Access Compliance Report Public Rights-of-Way (Curb Ramps)

Main Street: VALENCIA_AVE Cross Street: SANTE_FE_AVE Location: NE

ADA ID: RPAT220218171919 Ramp Type: Type 1 - Perpendicular Diagonal Initial Pass/Fail: Fail Overall Compliance: No Severity Score: 5

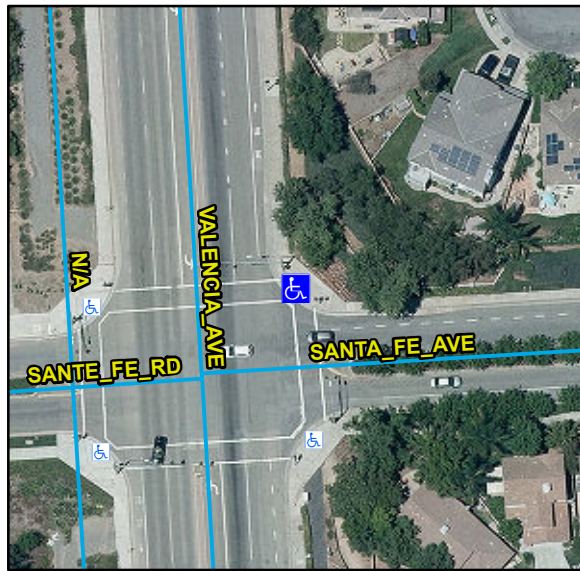
R304.2.2, R304.5.1, R304.5.3, STD 1115

Remove & Replace Curb Ramp With Two New Directional Ramps or Equivalent.
